TOWN OF BAY HARBOR ISLANDS
DEVELOPMENT & REVIEW COMMITTEE MEETING
RESCHEDULED, TUESDAY, NOVEMBER 15, 2022

1. Review and discussion of Site Plan Application by PPG BHT Owner, LLC to construct a 44-unit Multi-Family Development to be located at 10143 East Bay Harbor Drive. Enclosed are the Site Plans and the Staff Report prepared by Town Planner Michael Miller.
2. Review and discussion of Site Plan Application by CHBH 103rd Street, LLC, to construct a 77-unit Multi-Family Development to be located at 10200-10290 East Bay Harbor Drive. Enclosed are the Site Plans and the Staff Report prepared by Town Planner Michael Miller.
3. Review and discussion of Site Plan Application by DDG 1055 BHI, LLC, to construct a 9-unit Multi-Family Development to be located at 1055 93 Street. Enclosed are the Site Plans and the Staff Report prepared by Town Planner Michael Miller.

**TOWN OF BAY HARBOR ISLANDS
COMMUNITY DEVELOPMENT
MEMORANDUM**

Subject: Site Development Plan Application – DRC Review #3
Proposed New Multiple-Family Development (44 DU)
Existing Bay Harbor Tower Site (30 DU)
10141-10143 East Bay Harbor Drive
Bay Harbor Islands Acct. No. SPR22-000024
MMPA Acct. No. 01-0702-1142

Date	10-27-2022	Sheet No.	A2.00
Scale			
Project	0000

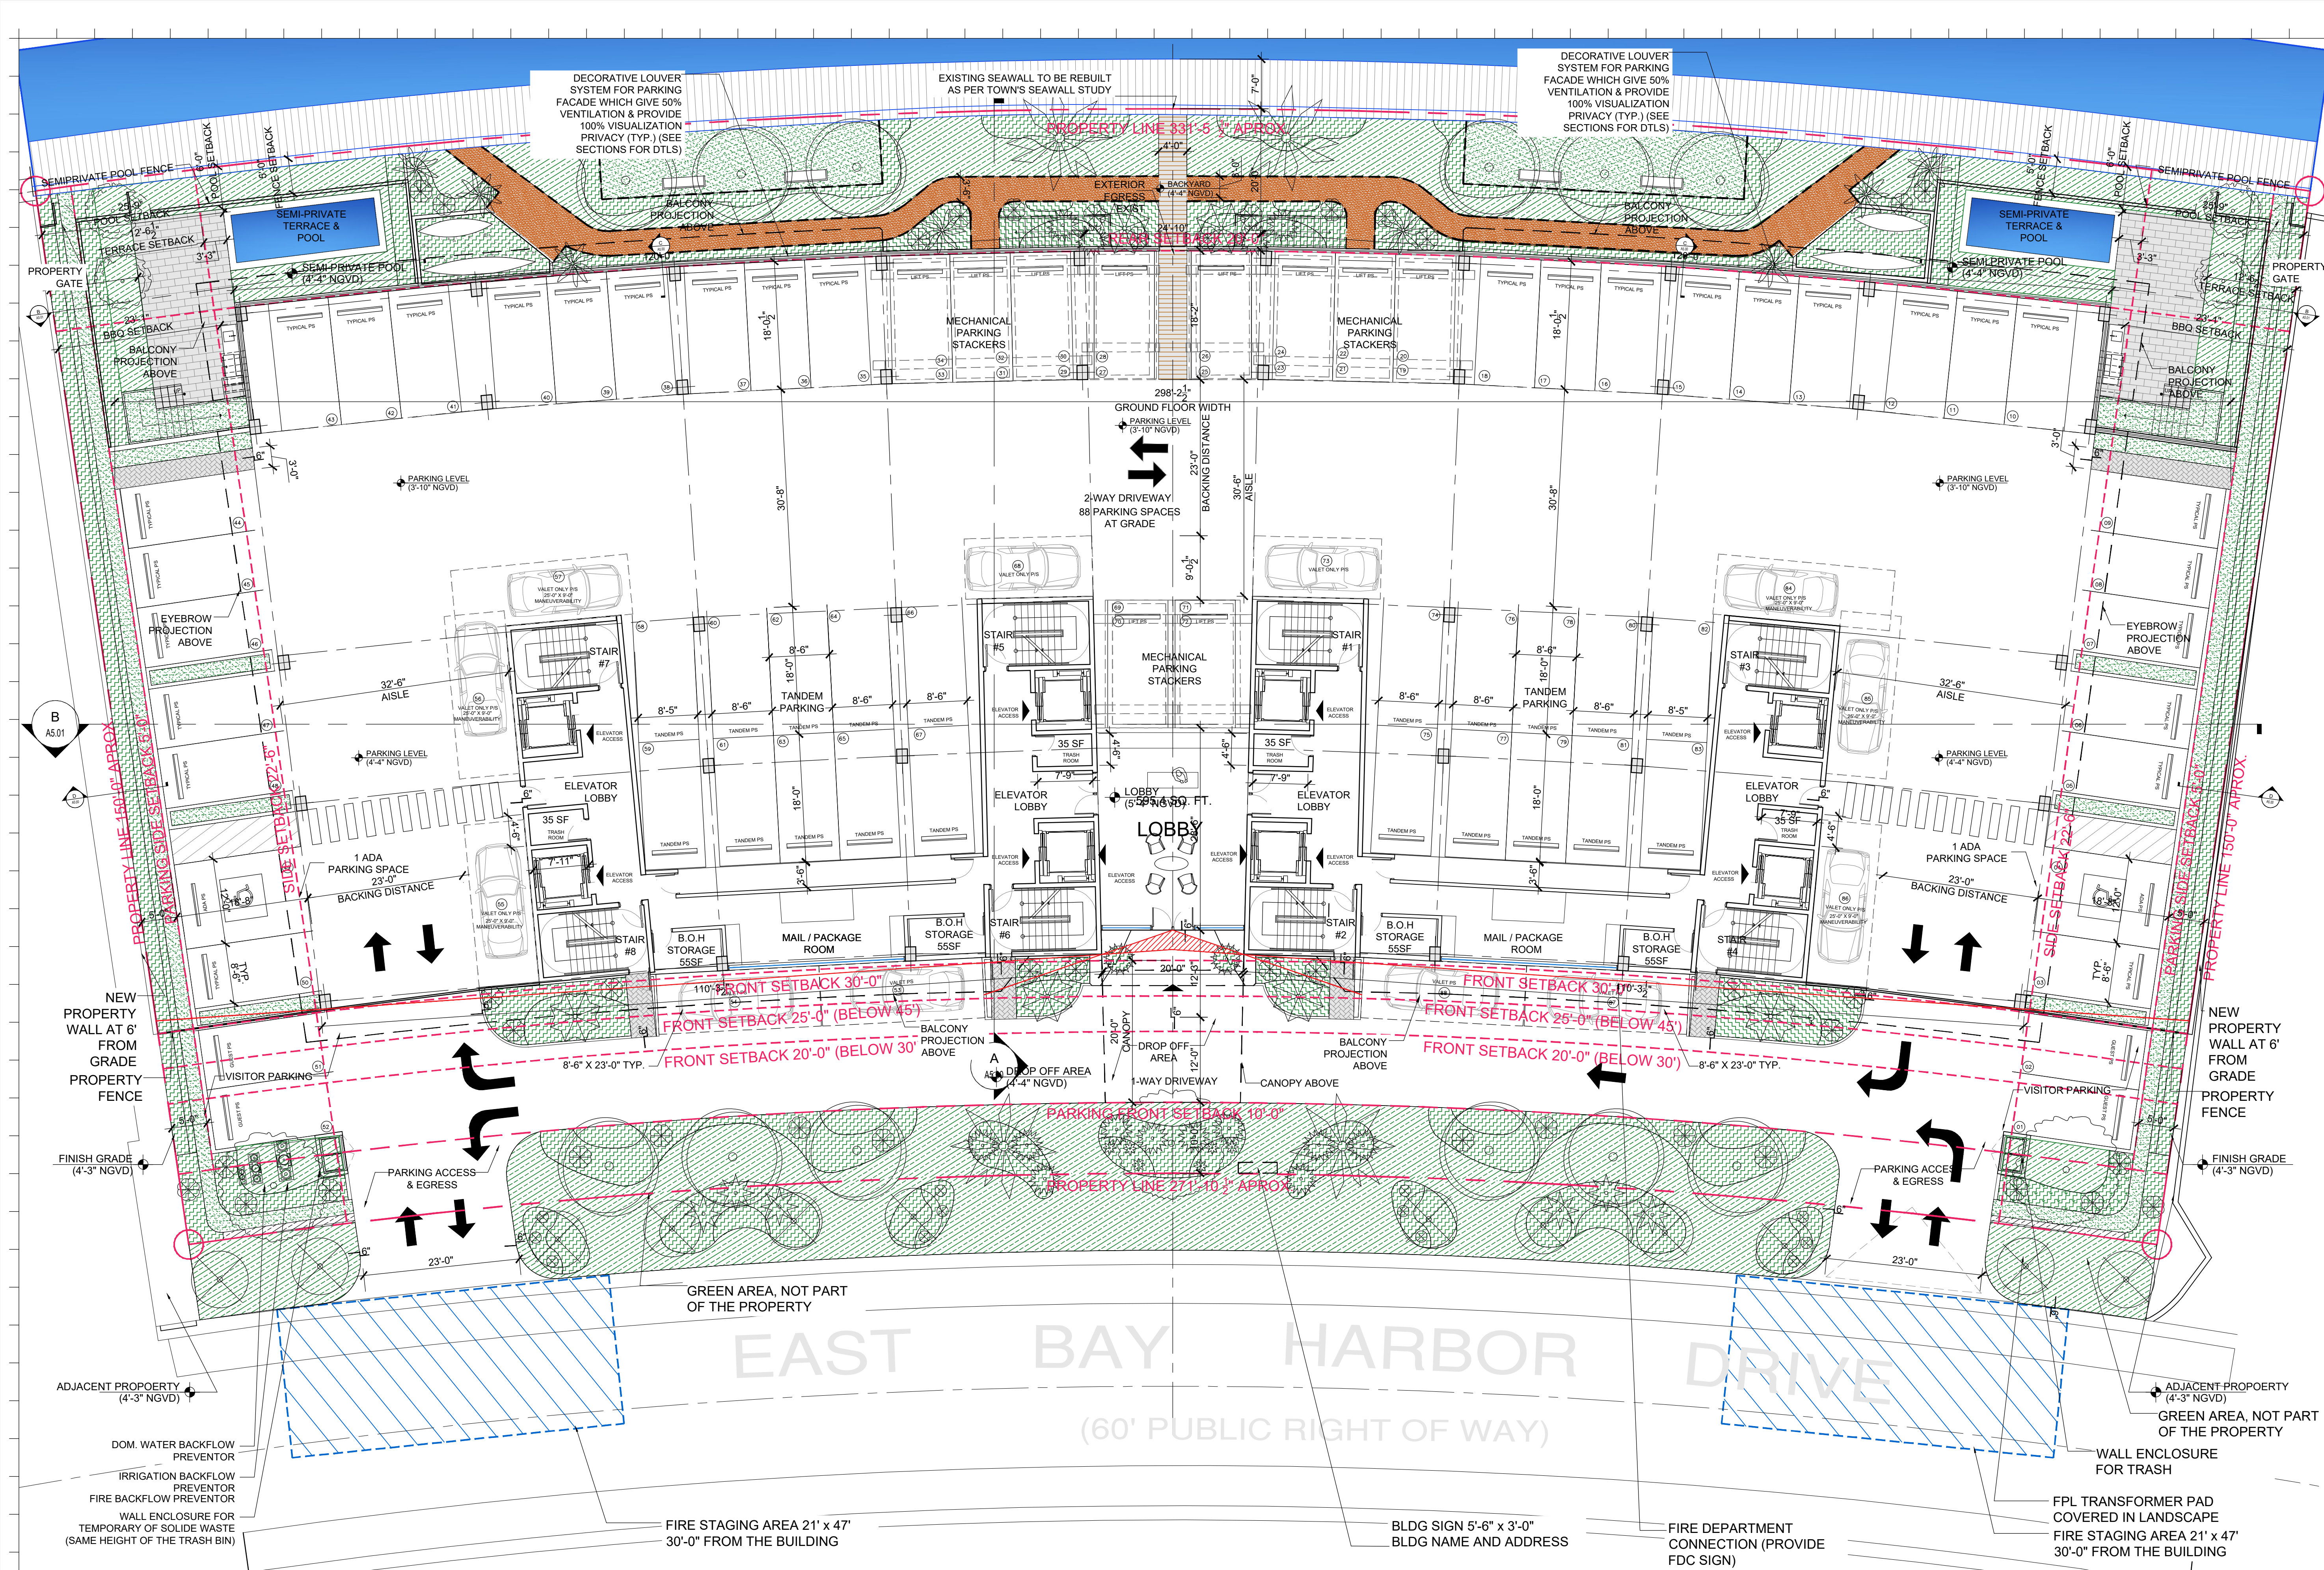
3	On Sheet A2.00 and Sheet A3.00 there are errors with the rear yard swimming pool locations and referenced Code sections. For waterfront sites Sec. 23-12(15)(g)(i) applies - not subsection (iv) as that applies to non-waterfront lots. Pools / pool decks can be located not less than 5' to the rear PL/ seawall - the plans show 7'-8" for some reason. You can leave them as shown or relocate them. However, Sec. 23-12(15)(g)(i) prohibits pools from being placed in the minimum side setbacks - the plans show the 2 semi-private pools partially within the min. 22.5' side setbacks. Please revise the plans accordingly.	Pools have been relocated, respecting minimal setbacks of 22.5', and 6' from the seawall/property lines. A2.00 & A3.00.
	4	On Sheet A2.00 I Sheet A3.00 I others there are setback violations shown for the proposed 3' wide walkways along the side lot lines. Per Sec. 23-12(15)(b) no such walkway may be placed closer than 3' to a side lot line, as this area is needed for drainage and buffering. The plans provide no setback dimension but a 5' setback from the parking spaces is shown with a 3' width shown for the walkway leaving only 2'. Also, a physical barrier to screen the parking areas from the adjoining sites are required per Sec. 24-16. Please revise the plans accordingly.	The walkway has been removed, and the area between the parking and the side lot line has been completely landscaped to work with the property wall as a physical barrier. Please see A2.00 and A3.00 & A5.00-B

5	On Sheet A2.00 I Sheet A3.00 I others there appears to be some type of private terraces near the semi-private swimming pools at grade level. Not enough detail is provided to determine Code compliance as to setbacks / materials/ roof coverings I height/ etc. The elevations seem to show a roofed structure - so setbacks are required. Please revise the plans accordingly. See Sec. 23-12(15)(e)(iii) for Code allowances.	Roofed Structure has been removed. Plans have been revised accordingly. A2.00 & A3.00.A5.01-B
	6	It appears that portions of the 5' raised rooftop pool deck do not meet the minimum 5' setback requirement from the edge of the main roof as required by Sec. 23-25(e). A parapet wall / railing not exceeding 5' above the roof deck is allowed at the edge of the main roof; however, if there is a raised pool deck, a similar safety railing / wall is allowed at the edge of the raised deck - but no closer than 5' to the edge of the main roof.	Please see sheet A5.00-B to find a detailed section of the area in compliance with this requirement.
